5th Avenue Bridge Planning Study

Community Engagement Summary | Open House #1

Top Map Comments:

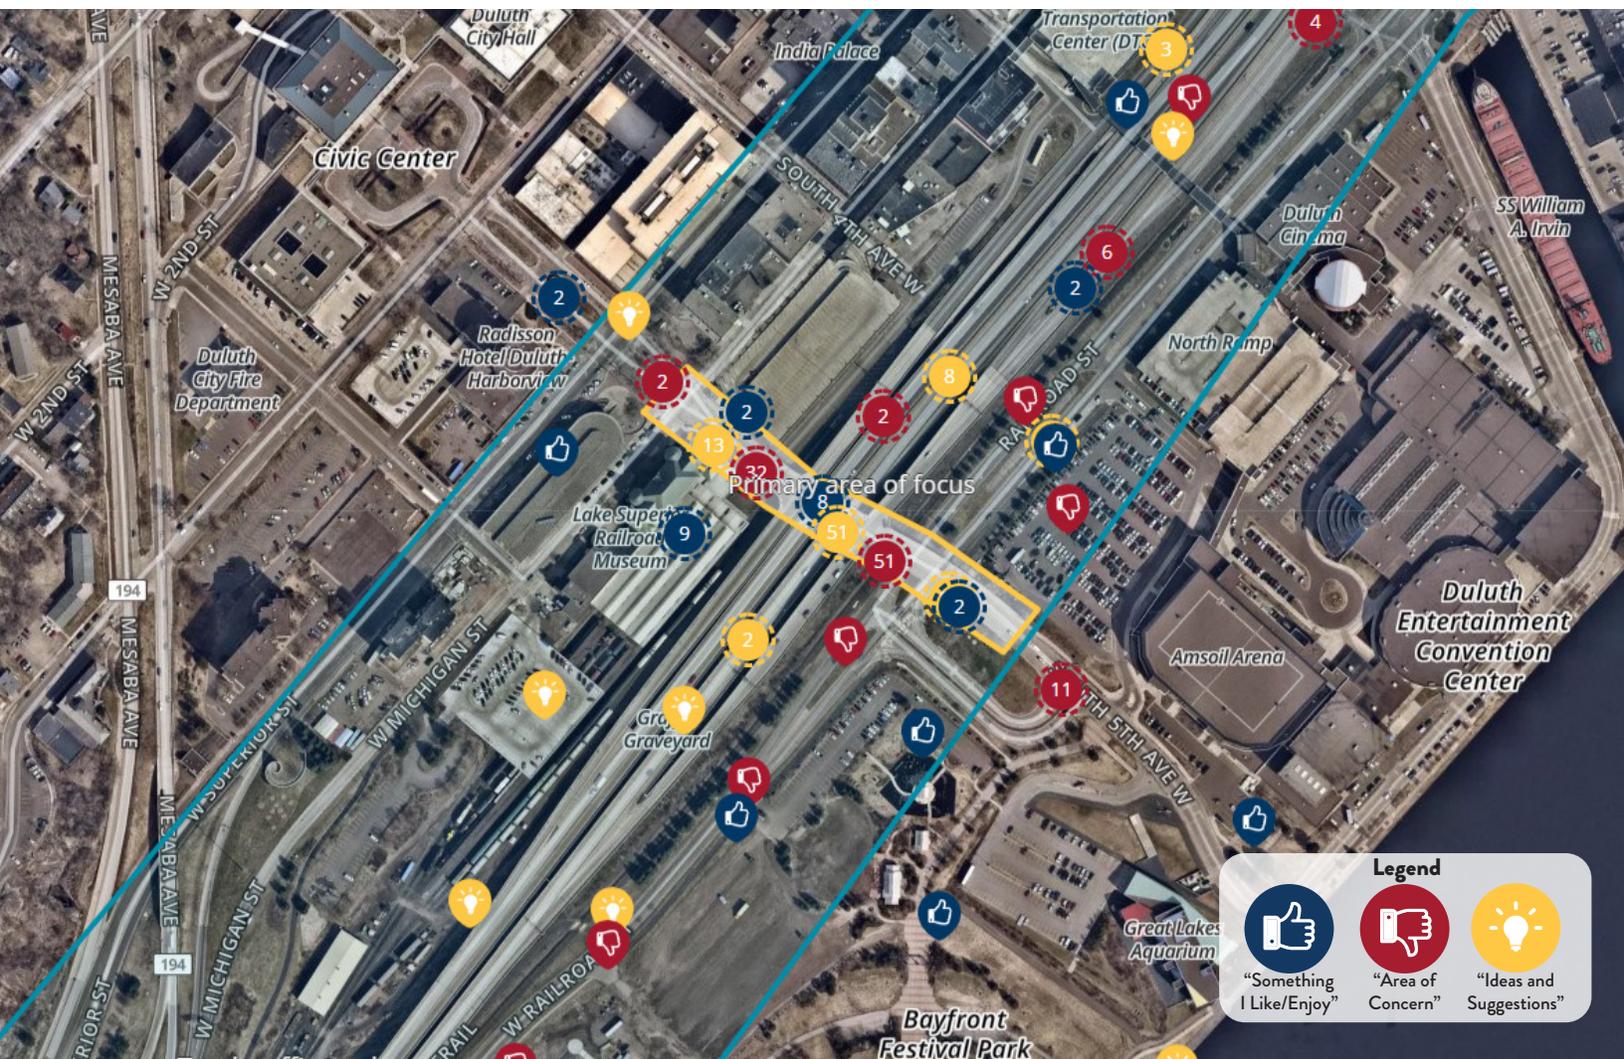
1. “Duluth needs to start following the example of other great cities and invest in long term solutions for walkable/“bikeable” urban areas. The Lake Abe bike lanes are completely unsafe and are confusing/dangerous for both drivers and cyclists. Following the recommendations of the Duluth Waterfront collective would revitalize this area and create a vibrant, safe, and environmentally sound solution to the combat the dangerous and car-centric situation in the 5th Ave and Lake Ave areas.”
(51 likes, 6 dislikes)

2. “Having the walkway on only one side of the bridge makes it more difficult to access, especially from Bayfront and the Playfront park located on the west side of 5th Ave West.”
(37 likes, 1 dislike)

3. “The overpass should be converted to an at grade roundabout intersection with the adjacent freeway being converted into a parkway with a grade-separated pedestrian path. This would help unbury the historic depot, make it possible to bike/walk between the Depot, the DECC, and Bayfront Park without crossing any traffic lanes, and allow for easy and direct traffic in/outflow from these areas during events.”
(41 likes, 7 dislikes)

4. “The fifth avenue bridge (much like the rest of I-35 through downtown Duluth) is a waste of good space that could be redeveloped into a more advantageous area for all business, citizens, and tourists in Duluth.”
(42 likes, 10 dislikes)

5. “The Depot should be visible from the waterfront and the waterfront should be visible from the Depot. The overpass completely obstructs this viewshed.”
(30 likes, 3 dislikes)
